NUCLEAR REGULATORY COMMISSION

Title: Advisory Committee on Reactor Safeguards
Design Center Licensing Subcommittee

Date: Thursday, January 20, 2022

10 CFR Part 50 vs. 10 Part 52 Licensing Processes

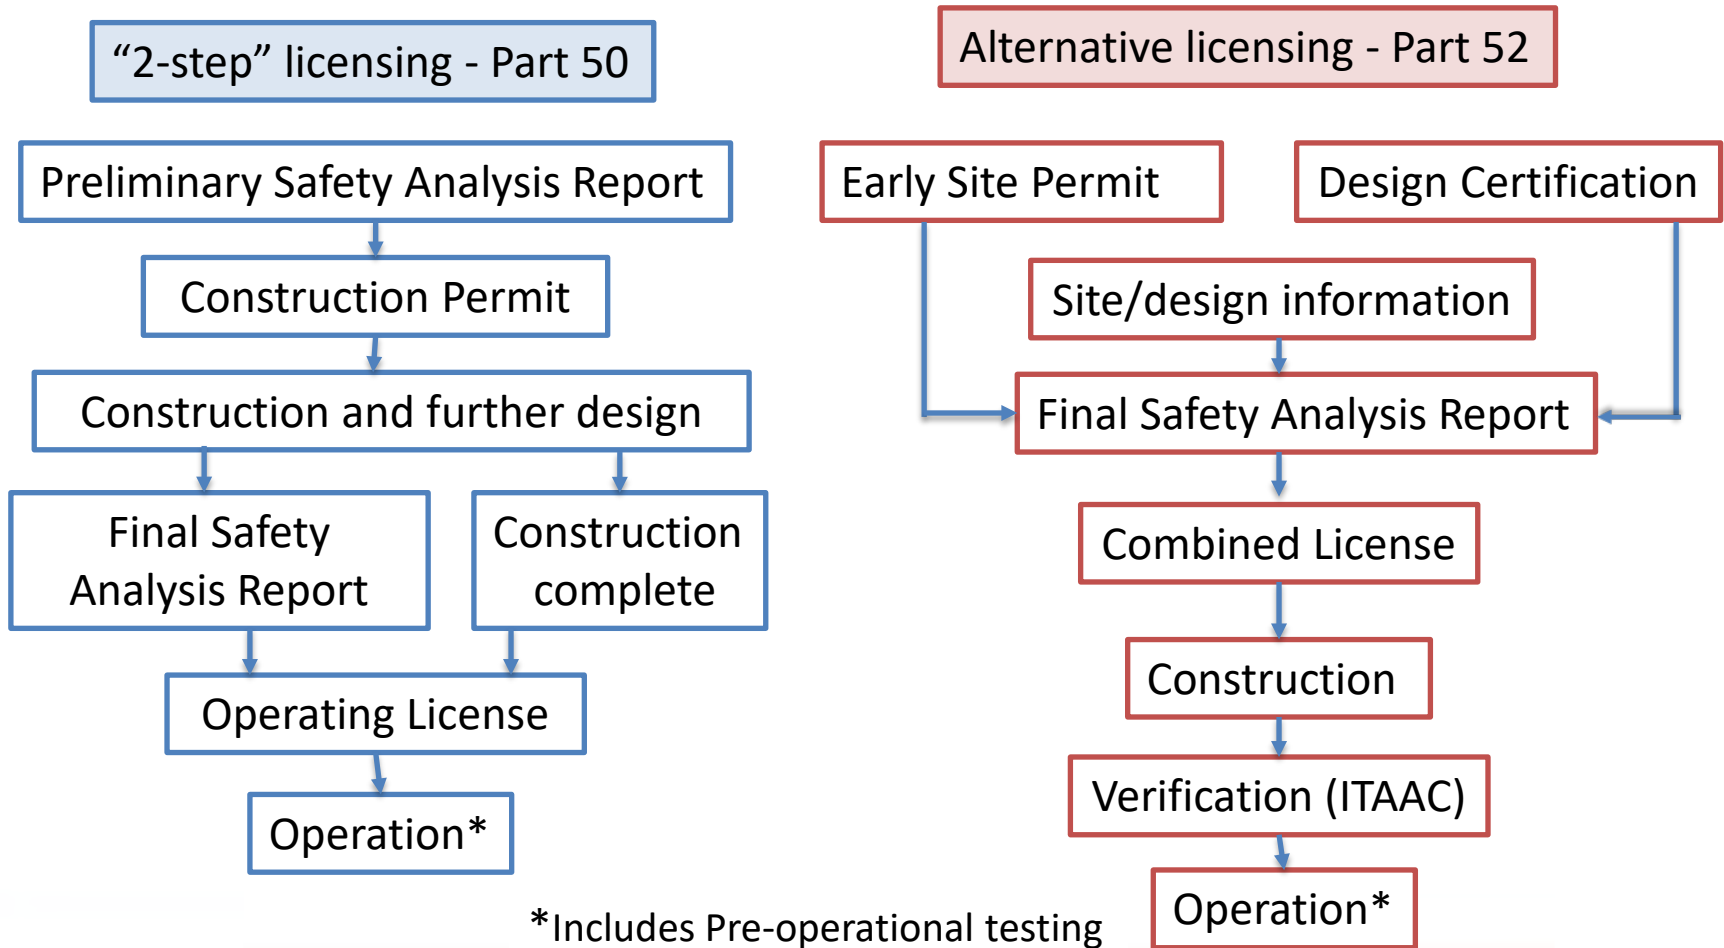
4 CHAIR REMPE: I'm sorry. I really like
5 diagrams, and these are a good step forward but
6 they're not consistent in what they show.

7 For example, these diagrams probably
8 should show the public interactions, which will appear
9 in the next diagram, right?

22 CHAIR REMPE: So, again, these are on your
23 website. And it would be nice if someone would fix
24 them and make them so they're consistent and show the,
25 some of the key parts in a consistent fashion, is my

12 MEMBER BROWN: All of these charts,
13 including the two back on Slide 6, which showed ACRS
14 meetings in both steps, they say meeting. This most
15 recent one you show now makes it more obvious. What's
16 that, Slide 11. 10 or 11, one of the two.

3 MR. DUDEK: Correct. I think there is a
4 level of detail possibly omitted for these. And I
5 will take that back for action.

5 MR. SHAMS: Certainly. And I'll take that
6 comment. We can add some notes to the cited document
7 to explain that this is just a sort of a, a bit of a
8 linear depiction of how this goes, but that's not the
9 way it goes. They overlap, they complement each other
10 and what have you. We can add that.

Engagement Envisioned for Hermes Review

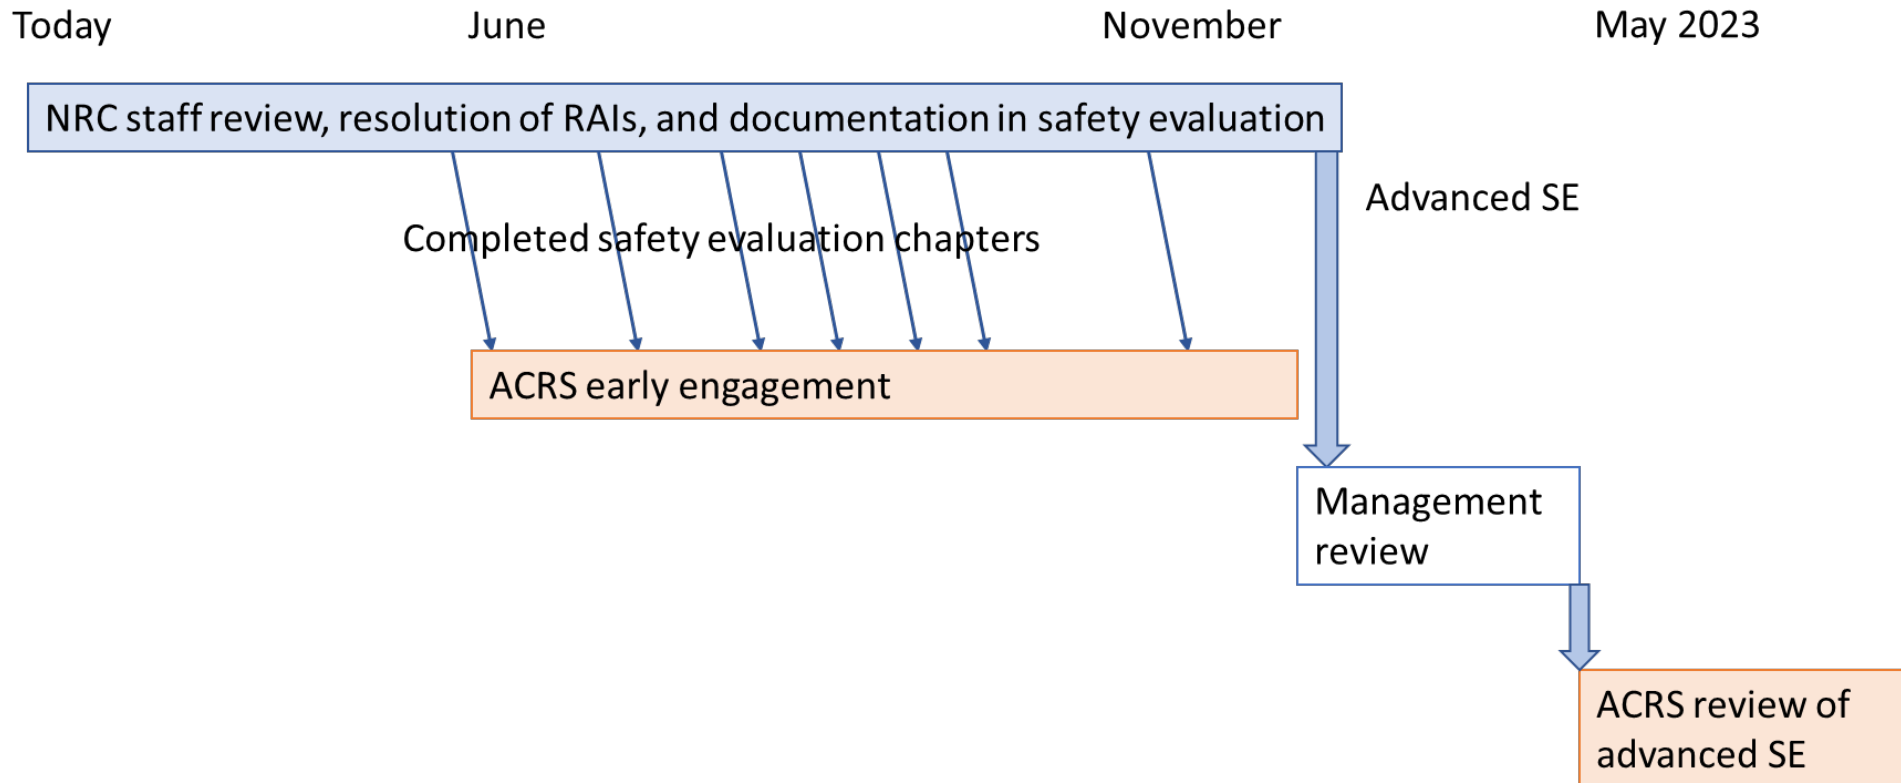
8 I would like to see more structure on
9 these interactions that show up in the Slide 28.
10 Because I think some structure to them, maybe grouping
11 what topics or chapters together for the discussions
12 would help facilitate the final review, as it did with
13 the SHINE process.
